MODIFICATION REQUEST:

Child Care Centre Modification

MP 09_0162 MOD 4 (Concept Plan)

MP 10_0177 MOD 13 (Project Application)

Figure 3: Proposed Concept Plan land use plan illustrating the enlarged childcare centre location
(Source: Proponent's EA)

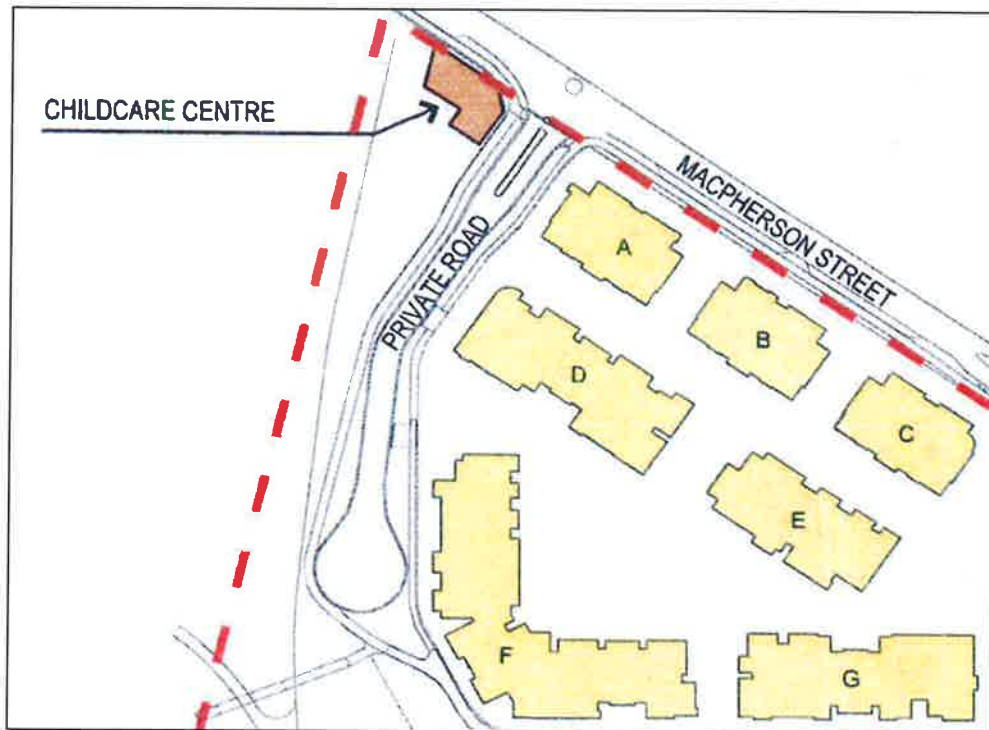
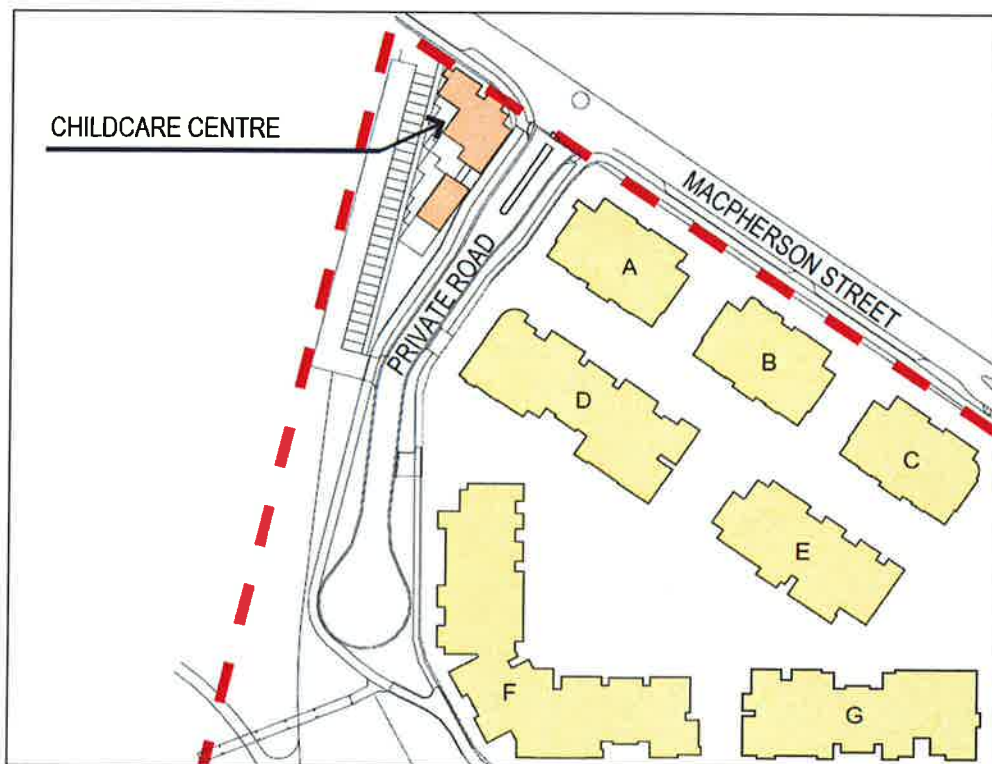
- an enlarged childcare centre through the provision of an additional storey (previous floor area of 270m², proposed 694.5m²);
- an enlarged car parking area (catering for 25 car parking spaces) located over an area to be dedicated to Council (**Figures 2 and 3** provide a comparison between the approved and proposed Concept Plan layout relating to the location of the childcare centre); and
- retention of existing dedication of land to Pittwater Council.

Figure 4: Proposed childcare centre and associated parking area (Source: Proponent's additional information)

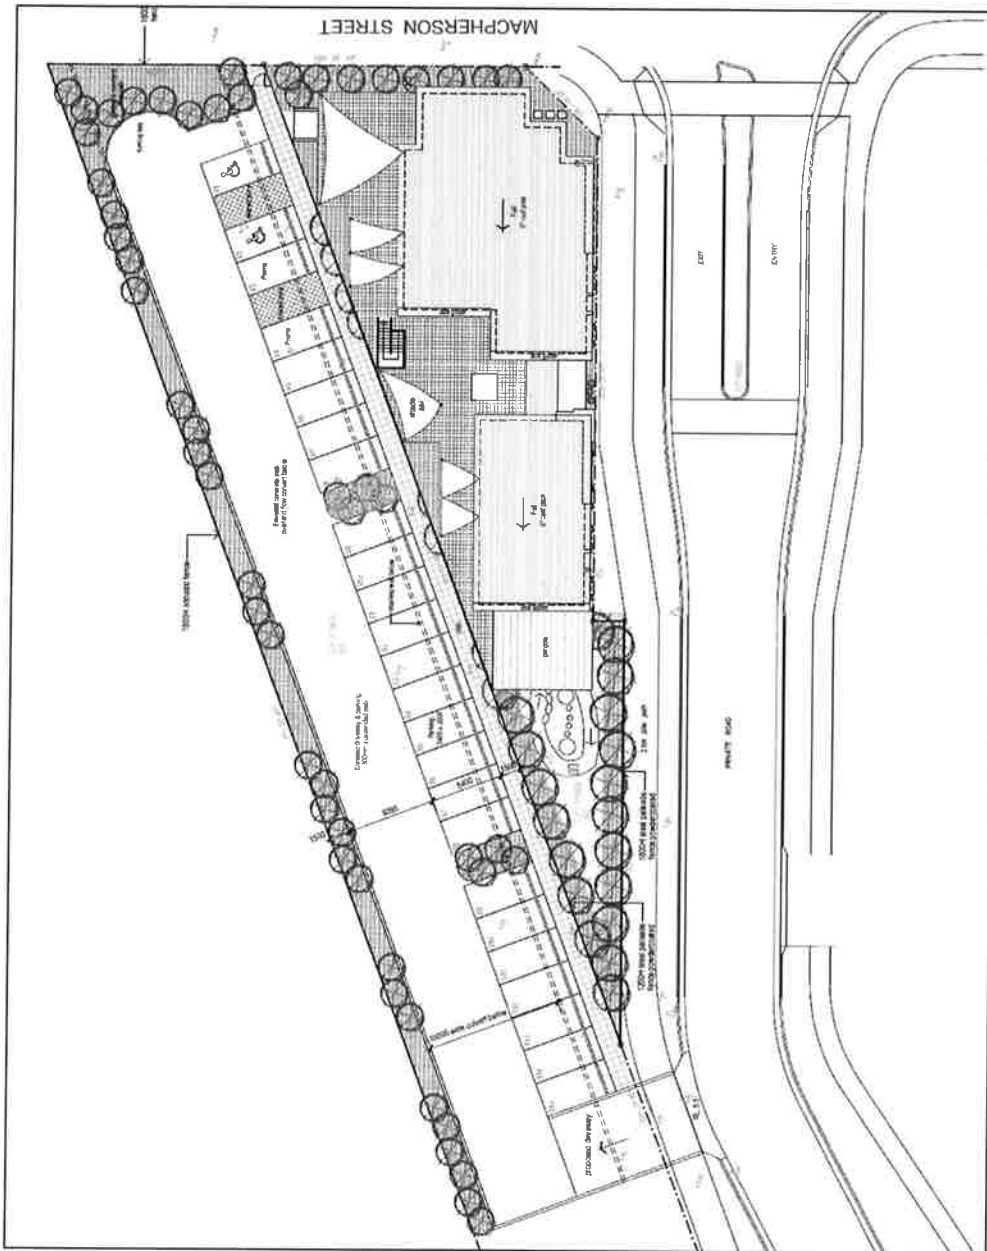
Vehicular access to the childcare centre is provided via an internal road accessed off Macpherson Street, through a dedicated car park entrance approximately 70 metres from Macpherson Street intersection (refer to **Figure 4** above). This access point is located on the opposite side of two driveways serving the existing residential development constructed to the east of the childcare centre on the proponent's site.

Council raised concerns with the proposed aisle width (6.395 metres) not being provided in accordance with AS2890 where parking space widths of 2.6 metres are to be provided. Council recommended that the aisle width be increased to 6.6 metres or alternatively an aisle width of 6.2 metres would be acceptable if 11 parking spaces assigned for the drop-off / collection of children be increased from 2.6 metres to 2.7 metres.

Council also raised concerns with the design of the car park and recommended the deletion of the closest car parking space to the proposed driveway to improve safety and eliminate conflicts. Given the proposed car parking provision is in-excess of RMS requirements (refer below), the department supports deletion of this space to provide for a more generous vehicular manoeuvring space into and out of the car park.

The department notes that a recommended increase in parking space width to 2.7 metres can be achieved with a reduction to the width of the two landscaped areas, combined with the removal of the car parking space that adjoins the proposed driveway. A suitable condition is recommended to address this issue.

The submitted car parking plan indicates the provision of 25 spaces, which is 2 spaces greater than the RMS requirement. As discussed above, the department recommends the deletion of 1 space to provide an improved car park entry and exit arrangement, which reduces the number of spaces to 24.

Figure 5: Extract of Stage 1 Project approved plan (Macpherson Street located on the right hand edge of the childcare facility and the overland flow path location added for context (green))

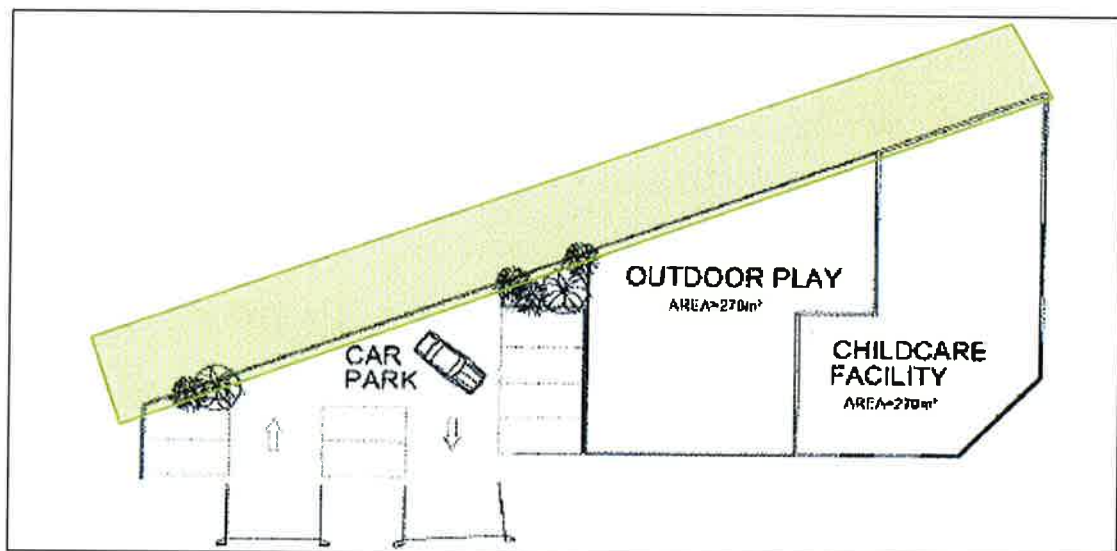
Council raised concern regarding the built form of the modified proposal and its impact on the streetscape. In particular, Council raised concern that:

- the two storey built form of the building and the car parking area would impact upon the streetscape and the residential amenity of the adjoining properties; and
- the nil setback to the Macpherson Street boundary (as originally exhibited) provides no opportunity for landscaping to soften the bulk of the building, unlike the residential buildings on the site and as provided for along Macpherson Street.

However, following concerns raised by Council and the department regarding the compatibility of the nil setback (having regard to the prevailing 6.5 metre setback of the adjacent 3-4 storey development), the proponent revised the design to provide a 2 metre setback to Macpherson Street to allow for landscaping to soften the appearance of the building and the car parking area.

Noting the above, the department considers that the proposed 2 metre setback addresses Council's earlier concerns in that it now provides for an opportunity for landscaping to soften the bulk of the building and the associated car parking area. Also, the department is of the view that despite the building including a 2 metre setback to Macpherson Street that does not match the 6.5 metres setback of the adjacent development, this is acceptable as it allows for outdoor play areas away from the street front.

Figure 8: Proposed car parking area to be constructed over overland flow path (Source: Proponent's additional information)

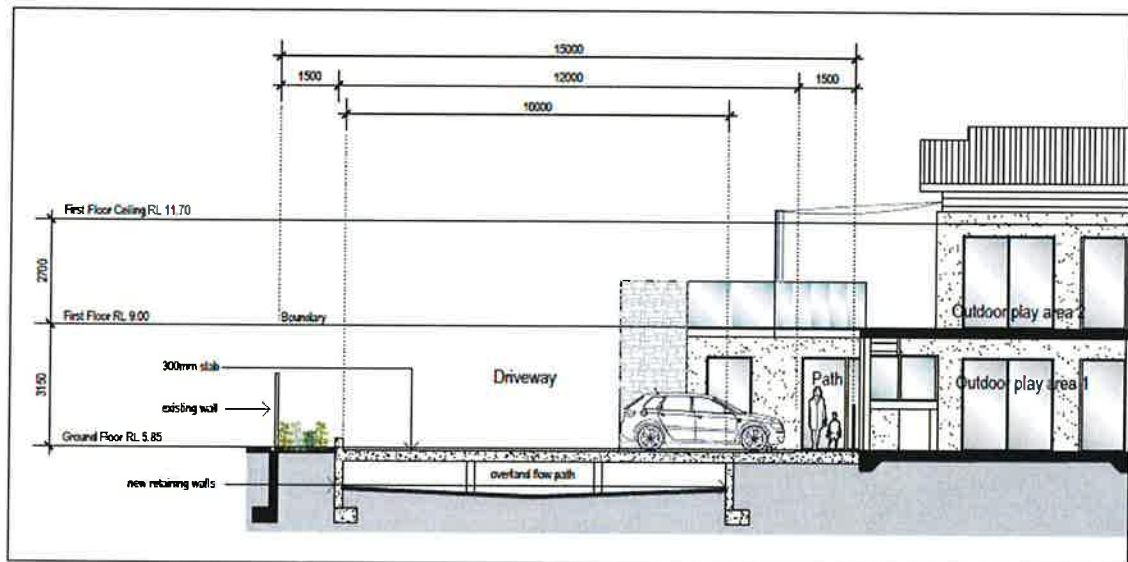
The proponent seeks to construct a car parking area servicing the childcare centre over an area designated as an overland flow path to within 1.5 metres of the western property boundary (**Figure 7**). The design of the car parking area incorporates a raised platform over the overland

flow path, providing a clearance of approximately 600mm from the bottom of the car parking platform and the top of the car parking area at a level of RL 5.80 (**Figure 8**).

Council raised concerns with the proposal to construct a car parking area over the overland flow path and questioned whether the proposed works would redirect overland flows onto surrounding properties. Additional justification was also requested to ensure that the proposed design does not impact upon the flood modelling, which considered impacts of the flood events up to the Probable Maximum Flood (PMF).

Having regard to these points, the department considers the proposed design to be acceptable and recommends that the final design of the car parking structure, to be prepared by a suitably qualified engineer, include consideration of the design and appropriate measures to ensure that the overland flow path is maintained and free of obstruction. The condition also requires details being provided to the Private Certifying Authority demonstrating consultation with Pittwater Council has occurred during this design process.

Figure 9: Area of land previously to be dedicated to Council now proposed to be covered by a car parking area, shown green (Source: Pittwater Council's submission to PPR)

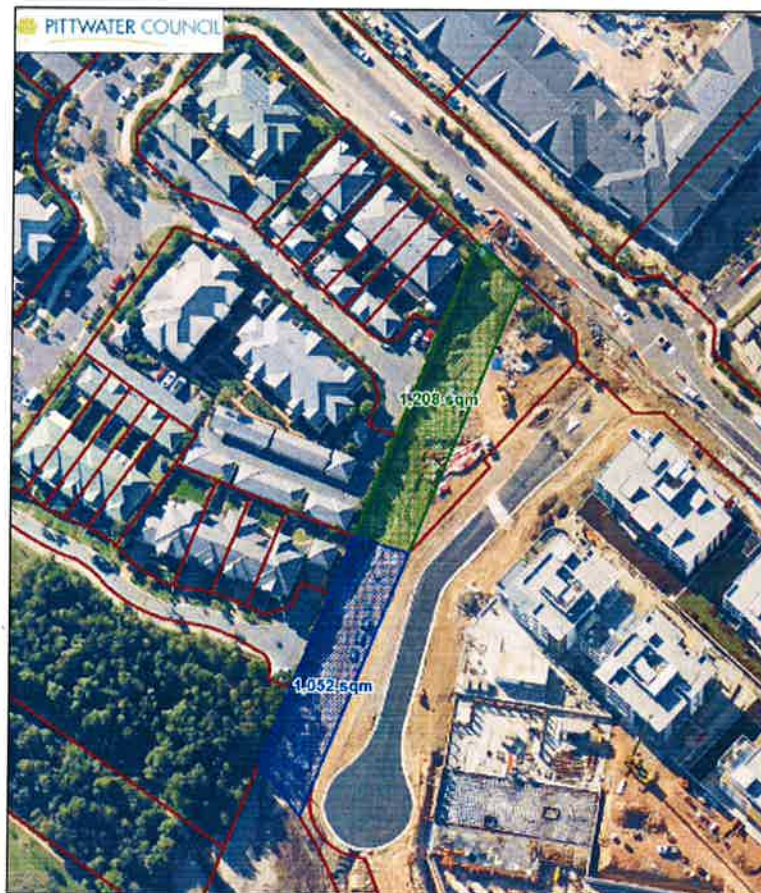
Council raised concerns that the proposed arrangement of constructing a private car park over the overland flow path, which was required to be dedicated to Council for public benefit, diminishes any public benefit. The Council contends that it cannot be utilised for public recreation and open space as originally intended. Council now considers that the whole overland flow path (2,260sqm) be excluded from the area to be dedicated to Council (**Figure 9** illustrates the area shown in green and blue) and that the offsets to Section 94 contributions be amended accordingly, i.e. greater contributions paid and a reduced area of dedication.

Council is also of the opinion that it should not be held responsible for the future maintenance of the overland flow path if there is to be a private structure built over it, which should be enforced through the creation of an appropriate instrument.

The department is supportive of Council's position that the utility of the overland flow path which now proposed to be covered by the car parking area (approximately 1,208sqm) is diminished in terms of public benefit as open space land. The department is however of the view that the remaining area, 1,052sqm to the south of the car parking structure (shown blue in **Figure 9**), can still be considered to provide a level of public benefit as originally considered. This is due to the fact that it remains connected to the larger portion of land to be dedicated to Council further to the south.

Based on the contribution rate previously determined in the Concept Plan of \$325 per sqm (as applied in the original Concept Plan approval), the department calculates a reduction to the offsets of \$392,600 for the area of the overland flow path covered by the car parking structure. Conditions of the Concept Plan and Stage 1 Project approval are recommended to be amended accordingly to address this revised arrangement.

To address Council's comments that it not be held responsible for the future maintenance of the overland flow path, the department has recommended that Condition B25 be incorporated in the Project approval requiring (underline added for emphasis):

- a) *Engineering plans and specifications for the car parking area located over the overland flow path are to be endorsed by a suitably qualified engineer prior the issue of the relevant Construction Certificate. Details are to include the design and measures proposed to ensure that the overland flow path is maintained and free of obstruction (by the developer or operator of the centre) and how access is to be provided should access be required. Documentation is to be provided to the satisfaction of the PCA demonstrating consultation with Pittwater Council.*
- b) *An easement is to be created relating to the area beneath the car parking area to be maintained (by the developer or operator of the centre) for the purpose of an overland flow path to the satisfaction of Pittwater Council.*
